**Brief comment:** This study observed erosion processes and some soil-hydrological properties at the headcut areas of two permanent gullies in Northeast China's Mollisols region during rainy and snow-melting seasons. Key parameters like soil moisture, temperature, and precipitation were investigated to understand water storage capacity, leakage processes, and suction stress levels. Although only two headcuts were monitored, I think the results could be of interest for the scientific community, but I would only recommend the publication of the work if a series of changes and improvements are carried out. In my opinion, the authors wrongly include methodological content and interpretations in the results section. These contents should be rightly placed in the corresponding section. Additionally, I miss some methodological details that I consider relevant (UAV data, processing, etc. see my comments below). Finally, figures must be notably improved, particularly the font size, please see my comments below. I detail these suggestions in the following lines:

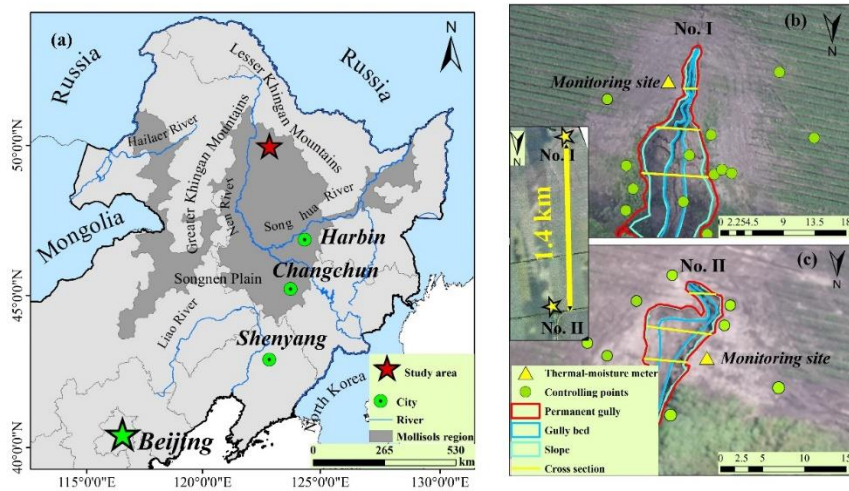
Figure 1. Should be improved, China is floating in the white. In general, some items in the figures are difficult to read, for example legend items in Figure 1c, the location map between 1b and 1c is impossible to see.

We revised the figure 1. The new figure is shown as follows:

**Fig. 2.** A close view of the over-steepen slope and headcut of the two permanent gullies, with (a) cross section and upstream view of the permanent gully No. I, (b) cross section and downstream view of the permanent gully No.

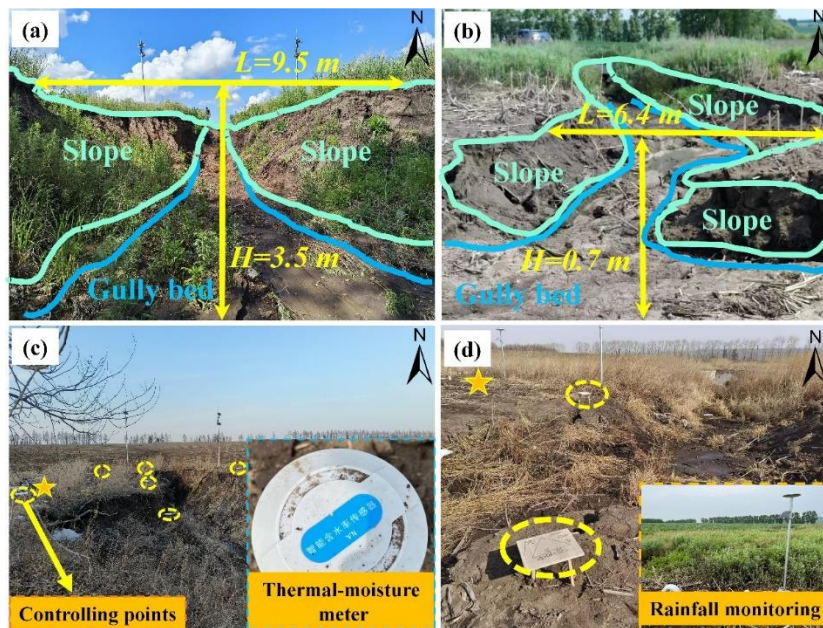
Fig. 2 Again some labels are very difficult to read, for example H in b.

Some labels in figure 2 are difficult to see. We improved the quality of the figure 2. The revised figure 2 is shown as follows:

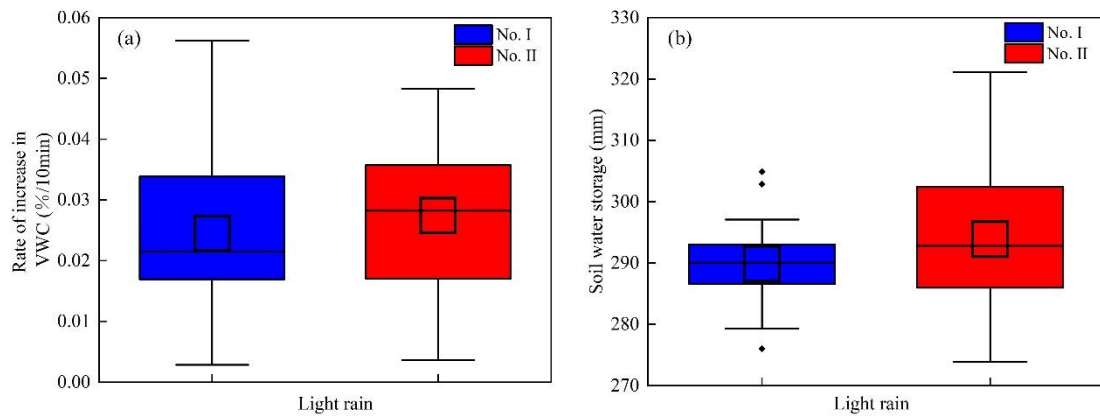
Fig. 8- I cannot see some details in (a), also happens in Fig. 9 (b)

We added a new figure to give a clear presentation of the figs. 8a and 9b.

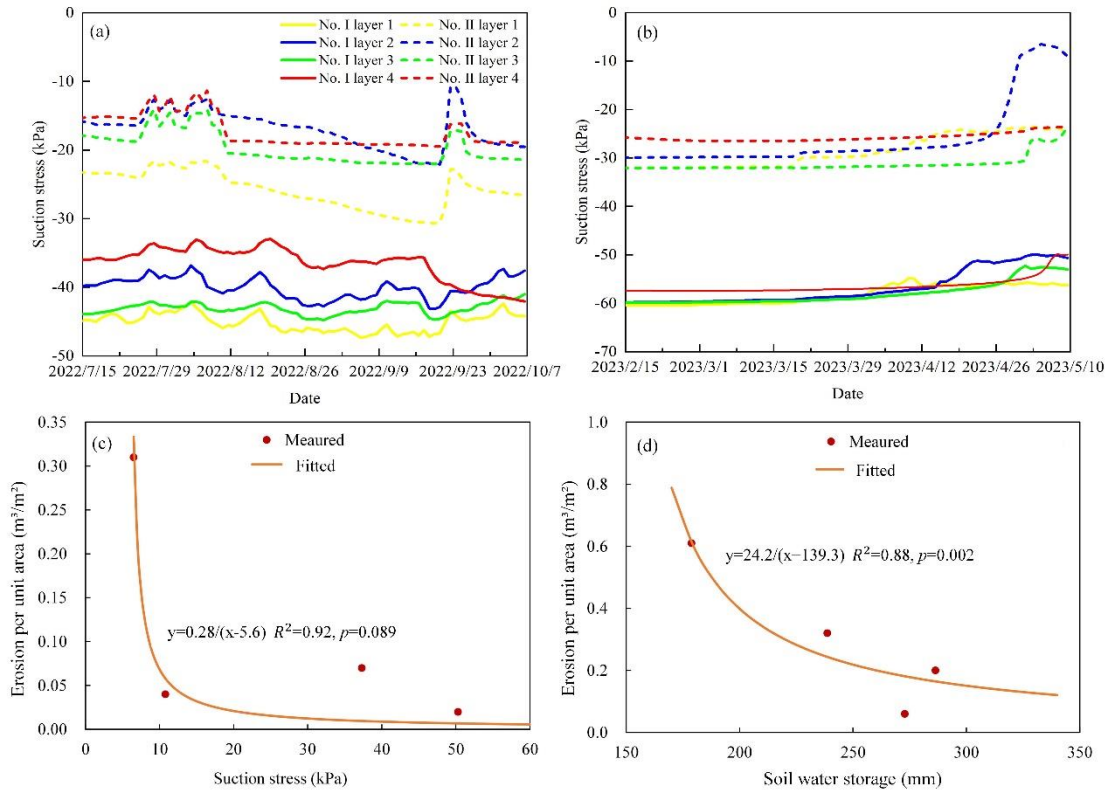
Fig. 10- the title of X-axis is not visible

We already revised it. Besides, the other two reviewers mentioned me that the  $R^2$  is not enough to support the significance of the fitted line. So, I inserted the P value in figs. 10a and 10b.
